STAFF RECOMMENDATION
613 17th Avenue North (MLK, Jr Academic Magnet School)
April 20, 2016

Application: New construction-addition
Map and Parcel Number: 09208001600
Council District: 19
Applicant: JC Elder, Bauer Askew Architecture
Project Lead: Robin Zeigler, robin.zeigler@nashville.gov, 615-862-7970

<p>Description of Project: The applicant proposes an addition (phase I.b.) to an addition approved in 2015.</p> <p>Recommendation Summary: Staff recommends approval with the conditions that staff provide final approval of masonry design, dimensions and color and metal colors and final approval of windows and doors. With these conditions, the project meets the design guidelines for new construction on a Landmark site.</p>	<p>Attachments A: Site Plan B: Elevations</p>
--	--

Figure 1: Shows the dates of construction for the MLK campus.

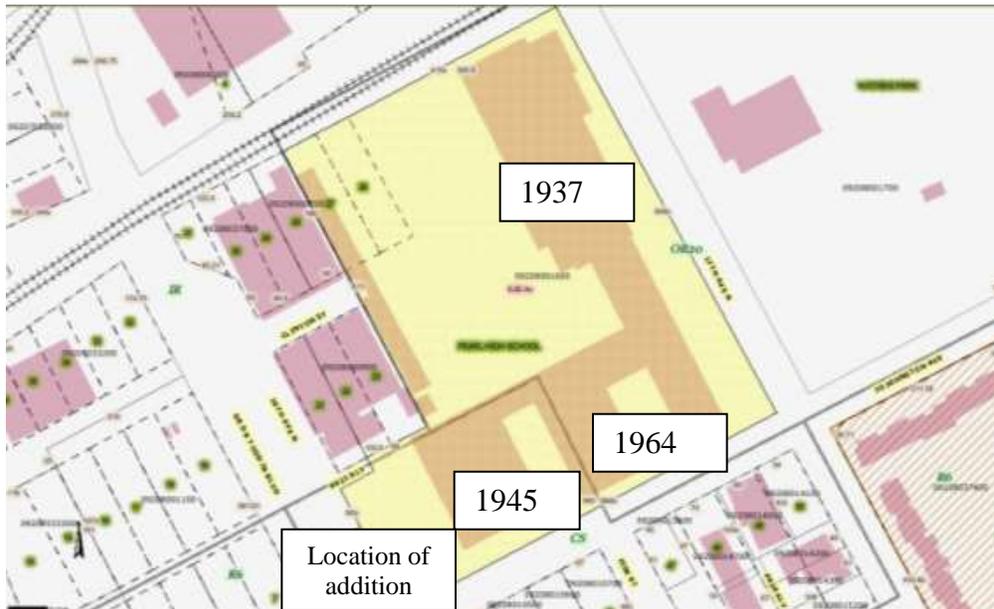
Building Site: The MLK, Jr. Academic Magnet High School is a local Historic Landmark. The primary historic 1937 portion of the campus faces 17th Avenue North. The proposed addition will be behind this portion with highly visible portions on Jo Johnston Avenue and Dr. DB Todd Jr. Blvd. (See figure 1.) It will be attached to the left side of the 1945 addition. (See figure 2.)

The proposed addition does not alter or remove significant features of the site. The location keeps the addition from detracting from the historic portions of the campus. There are no known archaeological areas in this heavily disturbed area. For these reasons, Staff finds the project to meet section II of the design guidelines.

Figures 1 and 2: The rhythm of openings and of façade articulation are similar to the historic building.

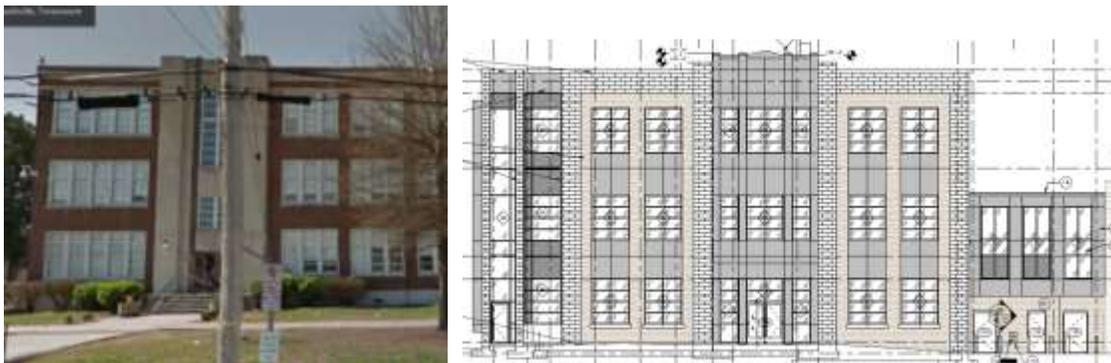
Compatibility of Openings: The rhythm of openings, window proportions, and window design are similar to the both the earliest historic building and the later 1945 addition. The project meets Secretary of Interior Standard 9.

ARCHITECTURAL SITE PLAN

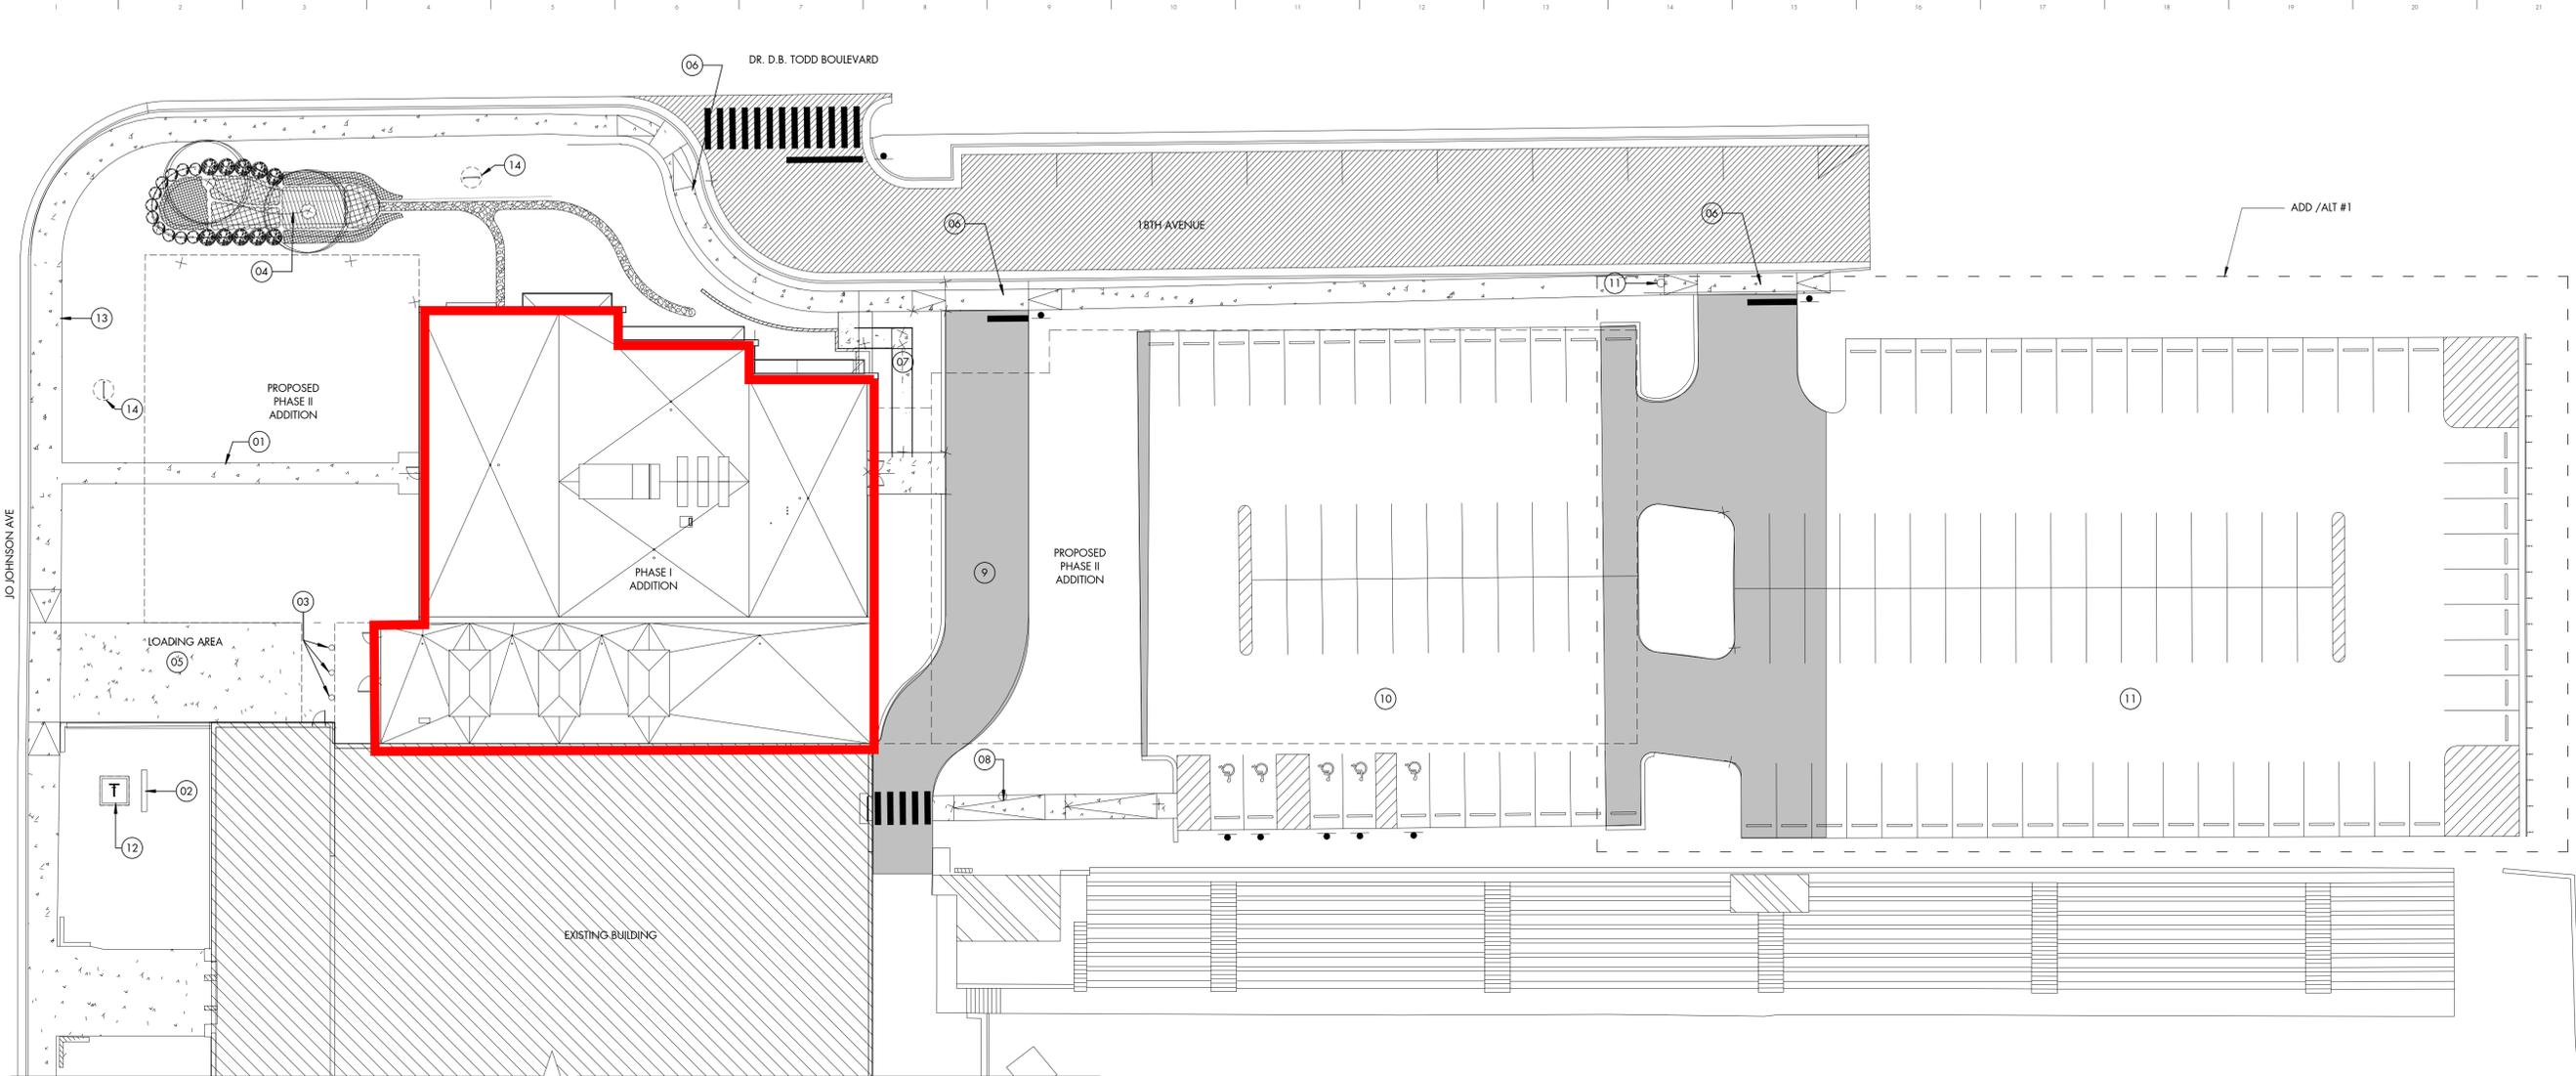
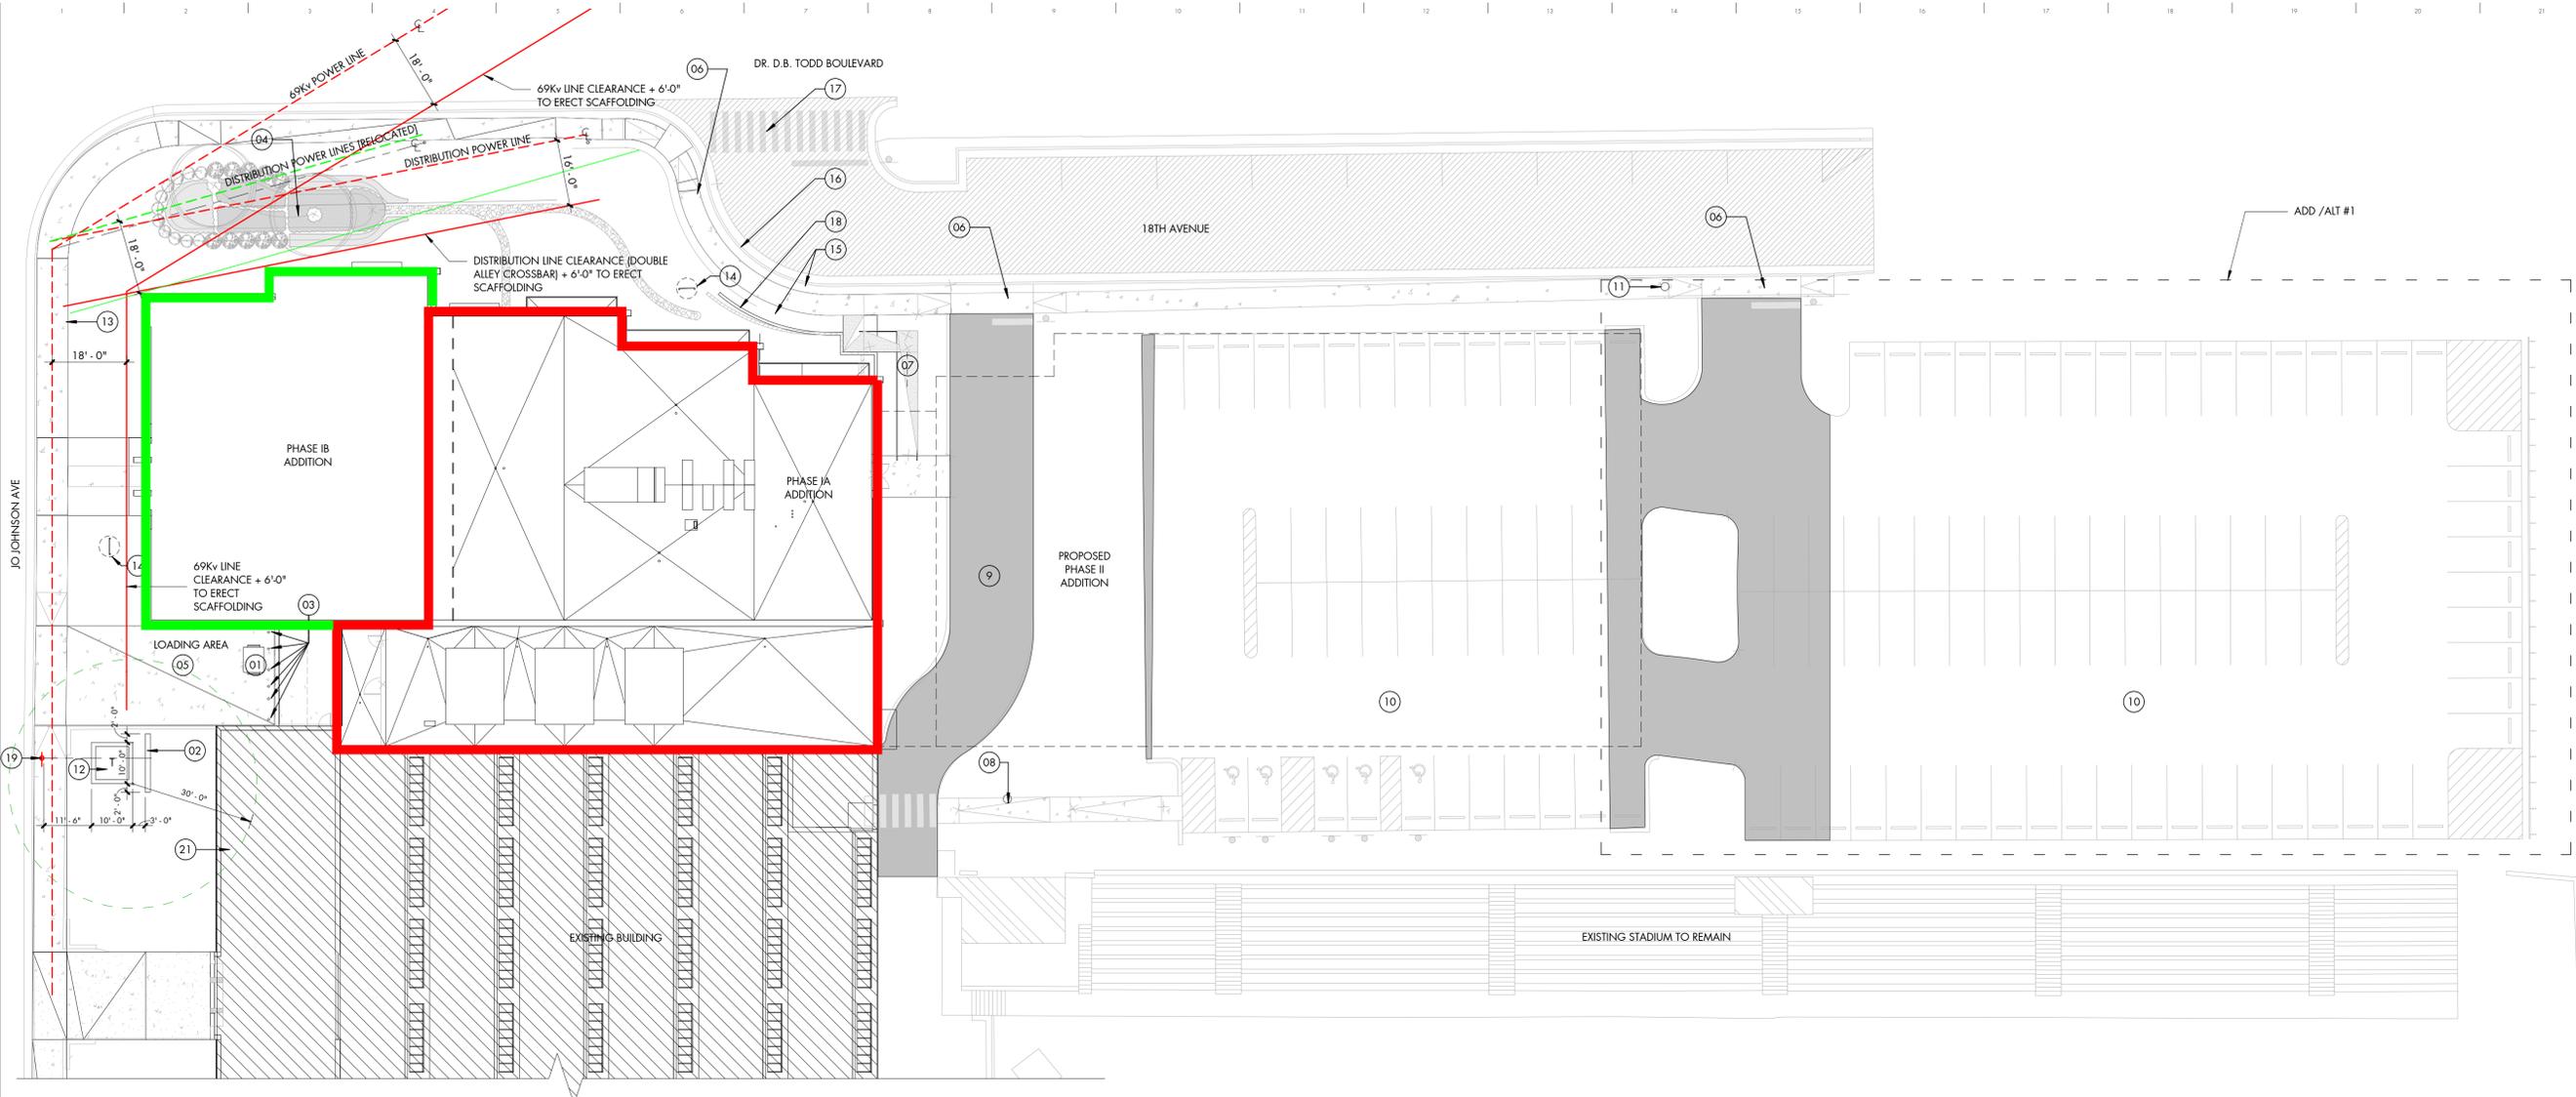
On August 19, 2015 the MHZC approved phase I.a. of this project which included removal of non-contributing buildings, the reorientation of parking and an addition,

behind the most significant building on campus and to the left of later historic additions. The proposed addition for phase I.b. will complete the previously approved addition.
